DOCKET No.: SA-521
EXHIBIT No. 7E

AIRWORTHINESS GROUP CHAIRMAN'S FACTUAL REPORT
ATTACHMENT IV: Douglas SB No. 27-262

Bulletin 27-262

FLIGHT CONTROLS - Elevator And Tab - Modify Elevator Geared Tab Mechanism.

ELEVATOR GEARED TAB MECHANISM - MODIFICATION

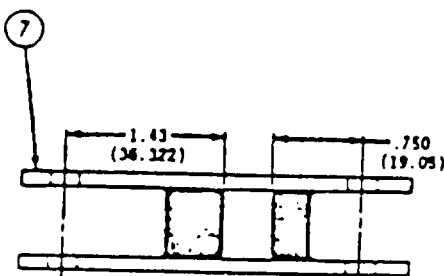
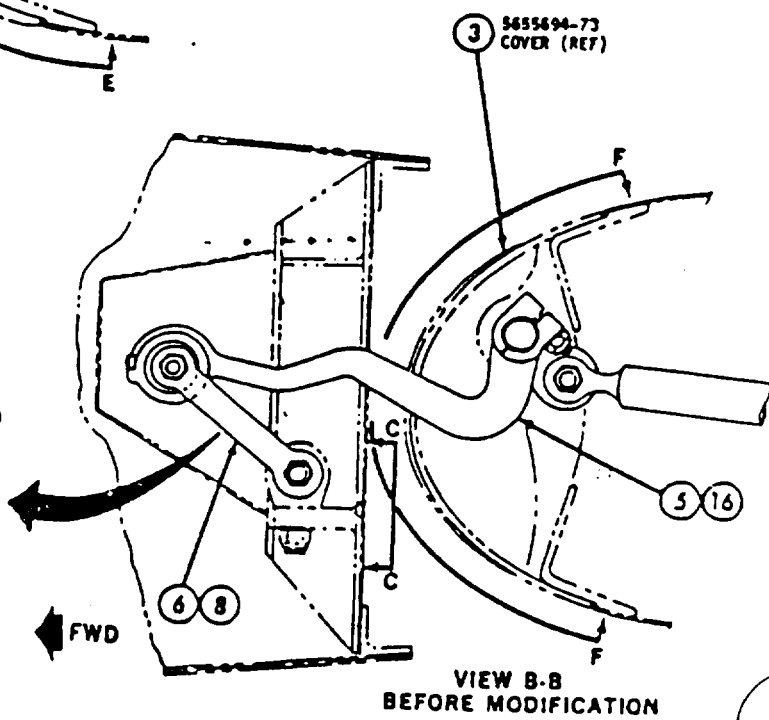
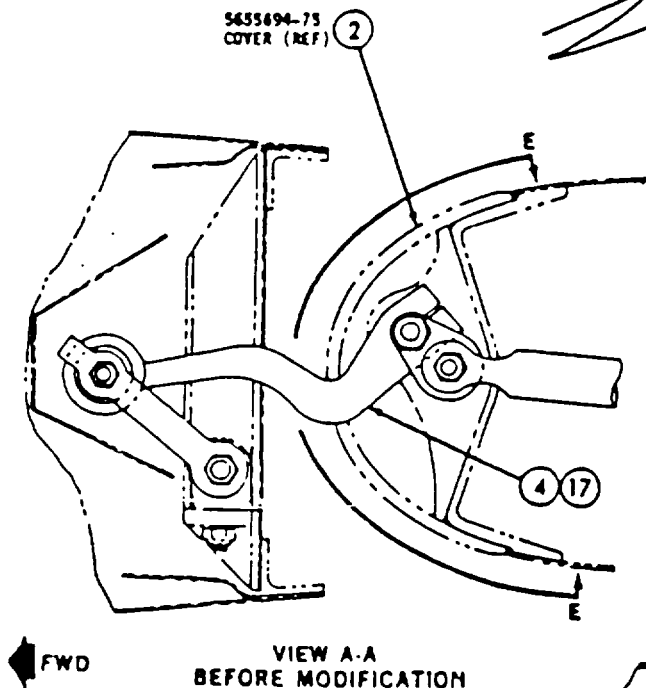
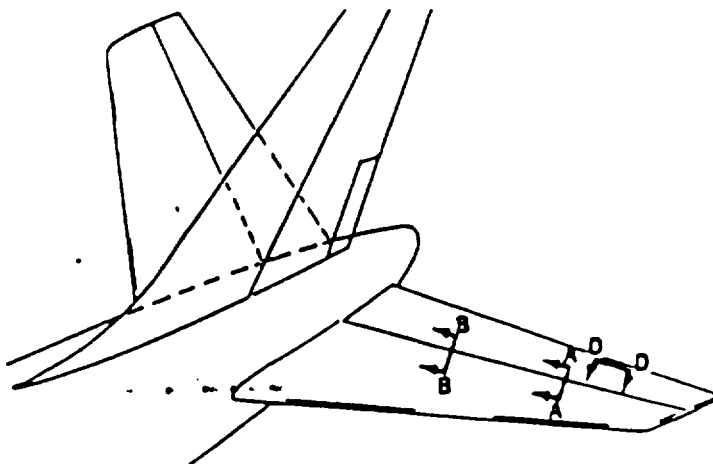
- ① (NOT SHOWN) REMOVE AND RETAIN ELEVATOR AND ATTACHING PARTS. (SEE MM CHAPTER 27-30-1, PARAGRAPH ENTITLED "REMOVAL/INSTALLATION ELEVATOR.")
- ② REMOVE AND RETAIN 5655694-75 COVER AND ATTACHING PARTS AT STATION X=192.250. (SEE VIEW A-A.)

- ③ REMOVE AND RETAIN 5655694-73 COVER AND ATTACHING PARTS AT STATION X=112.188. (SEE VIEW B-B.)
- ④ REMOVE AND RETAIN 4710542 ARM ASSEMBLY AND ATTACHING PARTS. (SEE VIEW A-A.)

- ⑤ REMOVE AND RETAIN 4710541 CRANK ASSEMBLY AND ATTACHING PARTS. (SEE VIEW B-B.)
- ⑥ REMOVE AND RETAIN 2710493-501 OR -503 LINK AND ALL ATTACHING PARTS, EXCEPT MS24665-151 COTTER PIN.

- ⑦ MODIFY LINK BY REMOVING MATERIAL AS SHOWN. REIDENTIFY AS 2710493-505 PER OPERATOR'S SHOP PRACTICE.
- ⑧ INSTALL MODIFIED AND REIDENTIFIED 2710493-505 LINK USING RETAINED ATTACHING PARTS AND NEW MS24665-151 COTTER PIN.

- ⑨ CHAMFER FITTING AT STATION X=112.188 AS SHOWN. (SEE VIEW C-C.)
- ⑩ ENLARGE CUTOUT IN ELEVATOR FORWARD SPAR AT STATION X=221.000 TO DIMENSIONS SHOWN. (SEE VIEW D-D.)

- ⑪ ENLARGE CUTOUT IN RETAINED 5655694-75 COVER TO DIMENSIONS SHOWN. REIDENTIFY MODIFIED COVER AS 5802769-7 PER OPERATOR'S SHOP PRACTICE. (SEE VIEW E-E.)

- ⑫ ENLARGE CUTOUT IN SKIN AT STATION X=192.250 TO DIMENSIONS SHOWN.
- ⑬ FABRICATE 5802769-3 AND -5 COVERS FROM RETAINED 5655694-73 COVER AS SHOWN. IDENTIFY COVERS AS 5802769-3 AND -5 PER OPERATOR'S SHOP PRACTICE. (SEE VIEW F-F.)

- ⑭ REMOVE AND RETAIN TWO MS21059L3 PLATE NUTS AND ENLARGE CUTOUT IN SKIN AT STATION X=112.138 TO DIMENSIONS SHOWN.
- ⑮ INSTALL TWO RETAINED MS21059L3 PLATE NUTS AS FOLLOWS:

- a. DRILL A NO. 10 HOLE AT DIMENSIONS SHOWN.
 - b. POSITION PLATE NUT OVER NO. 10 HOLE AND DRILL TWO NO. 40 HOLES USING EXISTING HOLES IN PLATE NUT AS GUIDES.

- c. COUNTERSINK NO. 40 HOLES 100° X .165-INCH DIAMETER (4.191) NEAR SIDE.
 - d. INSTALL PLATE NUT USING TWO MS20426A03-4 RIVETS.
- ⑯ REINSTALL 4710541 CRANK ASSEMBLY OR INSTALL NEW 3802767-1 CRANK ASSEMBLY, USING RETAINED ATTACHING PARTS. (SEE VIEW B-B.)

- ⑰ REINSTALL 4710542 ARM ASSEMBLY OR INSTALL NEW 3802768-1 CRANK ASSEMBLY, USING RETAINED ATTACHING PARTS. (SEE VIEW A-A.)
- ⑱ INSTALL MODIFIED AND REIDENTIFIED 5802769-7 COVER USING RETAINED ATTACHING PARTS. (SEE VIEW E-E.)

- ⑲ INSTALL 5802759-3 AND -5 COVERS USING RETAINED ATTACHING PARTS. (SEE VIEW F-F.)
- ⑳ (NOT SHOWN) INSTALLATION OF NEW 3802767-1 AND/OR 3802768-1 CRANK ASSEMBLIES WILL CHANGE WEIGHT OF EACH ELEVATOR APPROXIMATELY 1 POUND. ELEVATORS MAY BE REBALANCED AND BALANCE WEIGHTS REMOVED TO COMPENSATE FOR ADDED WEIGHT OF NEW CRANK ASSEMBLIES.

- ㉑ (NOT SHOWN) INSTALL MODIFIED ELEVATOR USING RETAINED ATTACHING PARTS. (SEE MM CHAPTER 27-30-1, PARAGRAPH ENTITLED "REMOVAL/INSTALLATION ELEVATOR.") REIDENTIFICATION OF MODIFIED ELEVATOR IS AT OPERATOR'S OPTION.

- ㉒ PERFORM CLEARANCE CHECK, AT APPROXIMATE POSITIONS NOTED, AS SHOWN. SLOWLY MOVE ELEVATOR THROUGH FULL RANGE OF TRAVEL AND VERIFY SPECIFIED MINIMUM CLEARANCE EXISTS. (SEE VIEWS A-A AND B-B, AFTER MODIFICATION.)

- ㉓ MODIFY ROD END AS SHOWN TO OBTAIN MINIMUM CLEARANCE AS REQUIRED.

ELEVATOR GEARED TAB MECHANISM - MODIFICATION
 FIGURE 1 (SHEET 7 OF 7)

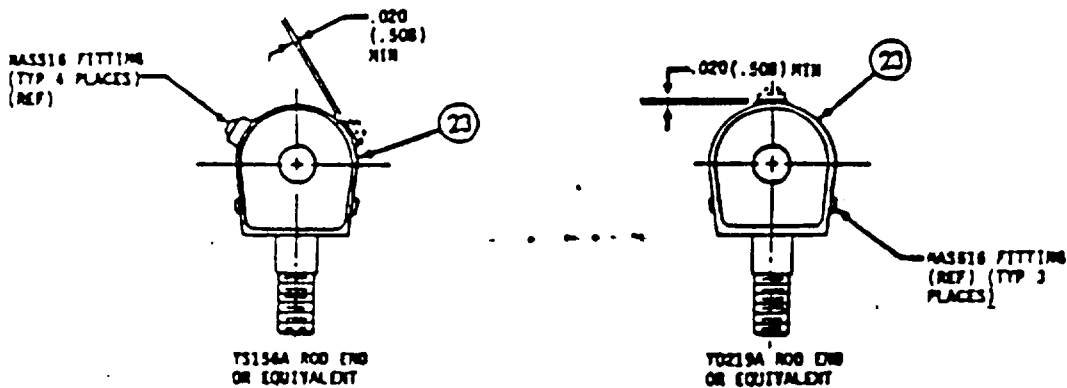
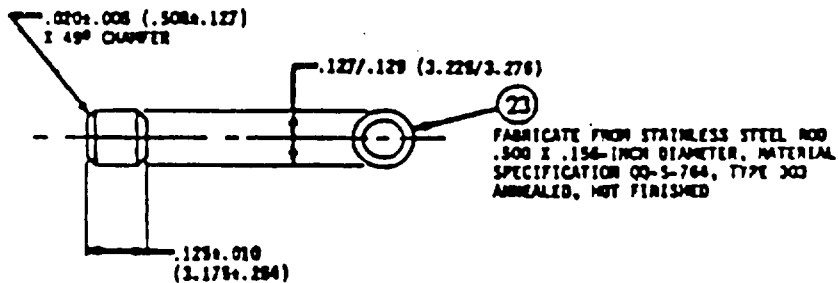
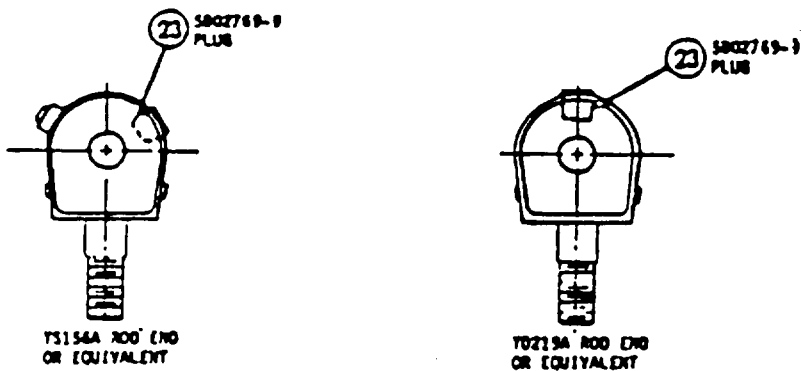
1. REMOVE HASS16 FITTING.
2. INSTALL S802769-9 PLUS PUNCH TO ROD END.
3. GRIND AS REQUIRED (NOT TO EXCEED .020 MINIMUM SHOWN).
4. TOUCH UP REMOVE AREA PER OPERATOR'S SHOP PRACTICE.

FABRICATE FROM STAINLESS STEEL ROD .500 X .156-INCH DIAMETER, MATERIAL SPECIFICATION QQ-S-764, TYPE 303 ANNEALED, HOT FINISHED

FIGURE 2 (SHEET 1 OF 6)

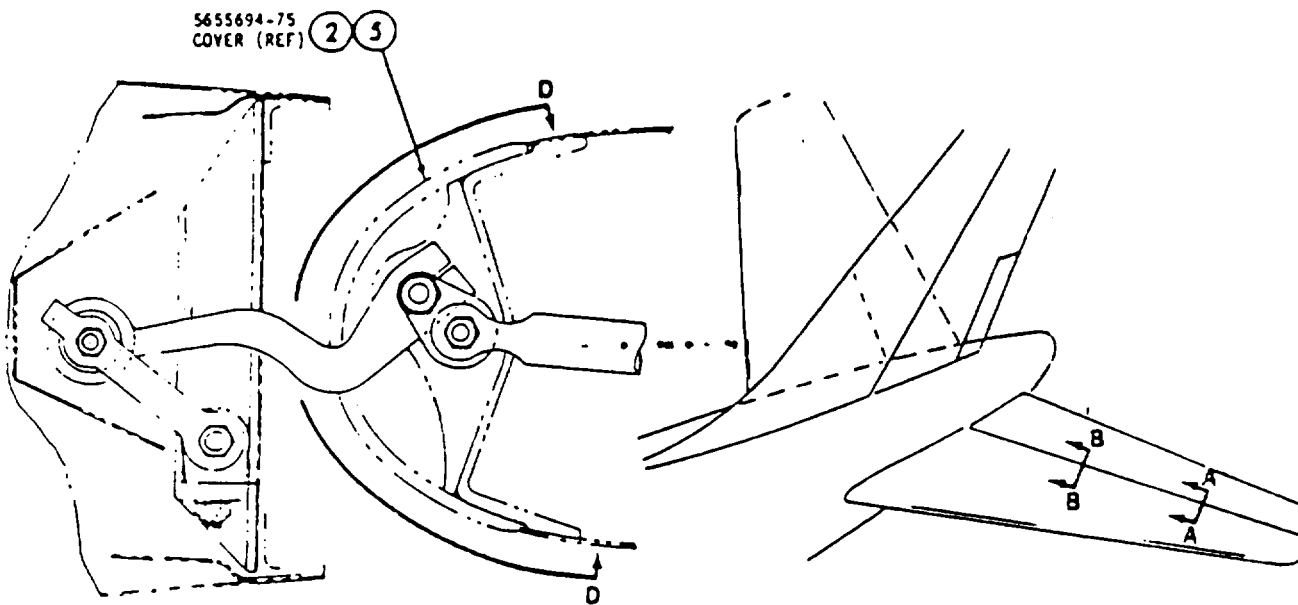
- ① (NOT SHOWN) POSITION ELEVATOR TRAILING EDGE UP (TEU) AND HOLD IN THIS POSITION.
- ② EXTEND LOWER PORTION OF EXISTING CUTOUT IN 5655694-7 SKIN AND 5655694-75 COVER. (SEE VIEW D-D.)
CAUTION: USE EXTREME CARE NOT TO DAMAGE 5655694-83 FITTING ADJACENT TO CUTOUT.

- ③ EXTEND LOWER PORTION OF EXISTING CUTOUT IN 5655694-5 SKIN AND 5655694-73 COVER. (SEE VIEW E-E.)
CAUTION: USE EXTREME CARE NOT TO DAMAGE 5655694-81 FITTING ADJACENT TO CUTOUT.

- ④ (NOT SHOWN) POSITION ELEVATOR TRAILING EDGE DOWN (TED) AND HOLD.
- ⑤ EXTEND UPPER PORTION OF EXISTING CUTOUT IN 5655694-7 SKIN AND 5655694-75 COVER. (SEE VIEW D-D.)
CAUTION: USE EXTREME CARE NOT TO DAMAGE 5655694-83 FITTING ADJACENT TO CUTOUT.

- ⑥ EXTEND UPPER PORTION OF EXISTING CUTOUT IN 5655694-5 SKIN AND 5655694-73 COVER. (SEE VIEW E-E.)
CAUTION: USE EXTREME CARE NOT TO DAMAGE 5655694-81 FITTING ADJACENT TO CUTOUT.

- ⑦ REIDENTIFY 5655694-75 COVER AS 5802769-11 PER OPERATOR'S SHOP PRACTICE.
- ⑧ REIDENTIFY 5655694-73 COVER AS 5802769-13 PER OPERATOR'S SHOP PRACTICE.
- ⑨ REMOVE AND RETAIN 2710493-501 OR -503 LINK AND ALL ATTACHING PARTS, EXCEPT MS24665-151 COTTER PIN.

- ⑩ MODIFY LINK BY REMOVING MATERIAL AS SHOWN. REIDENTIFY AS 2710493-505 PER OPERATOR'S SHOP PRACTICE.
- ⑪ INSTALL MODIFIED AND REIDENTIFIED 2710493-505 LINK USING RETAINED ATTACHING PARTS AND NEW MS24665-151 COTTER PIN.

- ⑫ (NOT SHOWN) POSITION ELEVATOR TRAILING EDGE DOWN (TED) AND HOLD.
- ⑬ CHAMFER FITTING AT STATION X=112.188 AS SHOWN. (SEE VIEW C-C.)
- ⑭ PERFORM CLEARANCE CHECK, AT APPROXIMATE POSITIONS NOTED, AS SHOWN. SLOWLY MOVE ELEVATOR THROUGH FULL RANGE OF TRAVEL AND VERIFY SPECIFIED MINIMUM CLEARANCE EXISTS. (SEE VIEWS A-A AND B-B, AFTER MODIFICATION.)

- ⑮ MODIFY ROO END AS SHOWN TO OBTAIN MINIMUM CLEARANCE AS REQUIRED.

ELEVATOR GEARED TAB MECHANISM - MODIFICATION

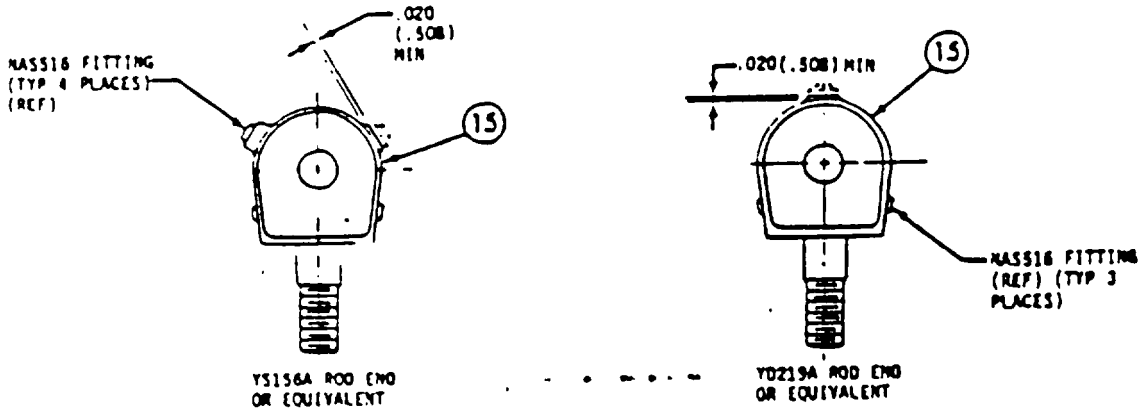
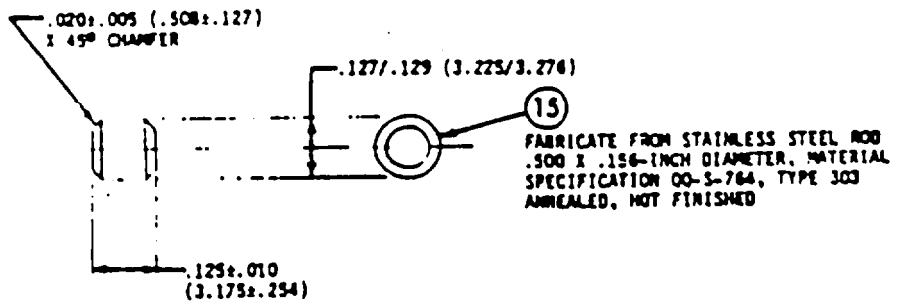
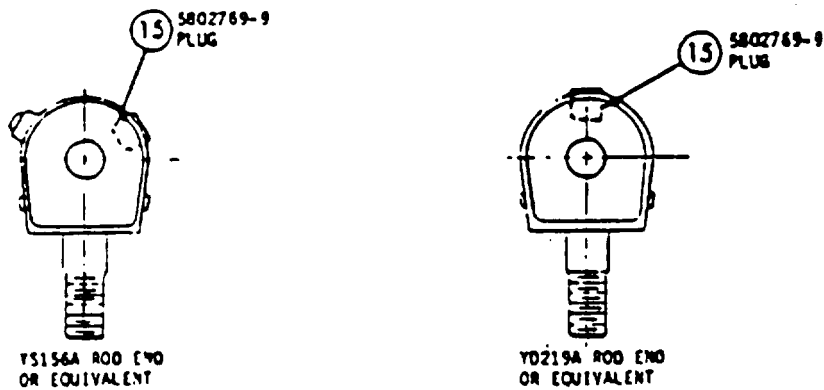
1. REMOVE MASS16 FITTING.
2. INSTALL 5802769-9 PLUG FLUSH TO ROD END.
3. GRIND AS REQUIRED (NOT TO EXCEED .020 MINIMUM SHOWN).
4. TOUCH UP REWORK AREA PER OPERATOR'S SHOP PRACTICE.
